N192266190 Engine Control Software Issue

Release Date: October 2019

Revision: 02

Revision Description: This bulletin has been revised to update the service procedure for the XT5 vehicles involved in this recall. Please discard all previous copies of bulletin N192266190.

1. Reprogram the Engine Control Module. Refer to *K20 Engine Control Module: Programming and Setup* in SI.

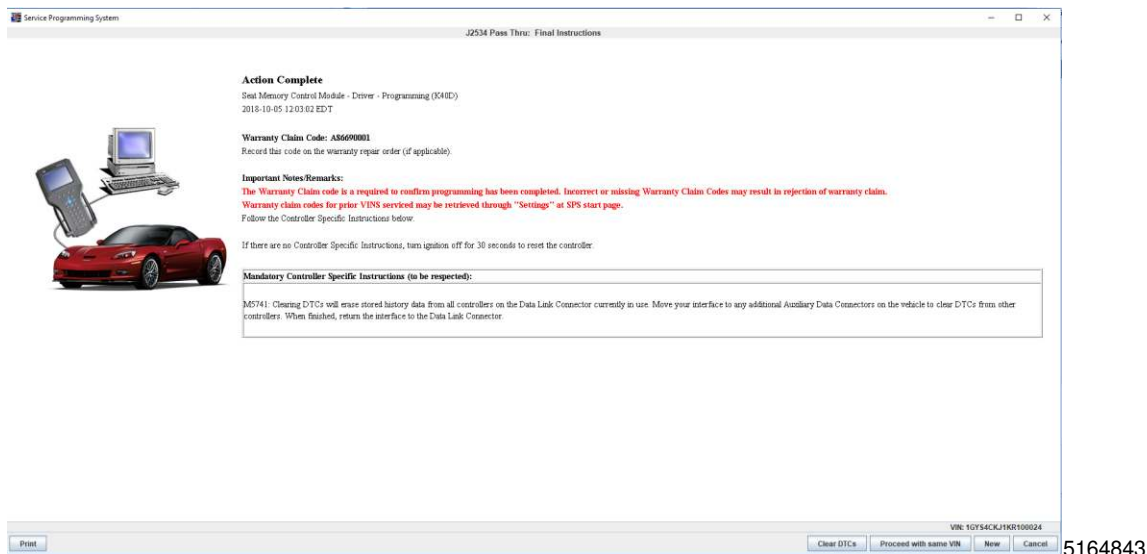
- **Please note, ECM and TCM programming are sequenced on the XT5, however no new TCM calibration has been released for that vehicle since launch, so programming will skip the TCM.**
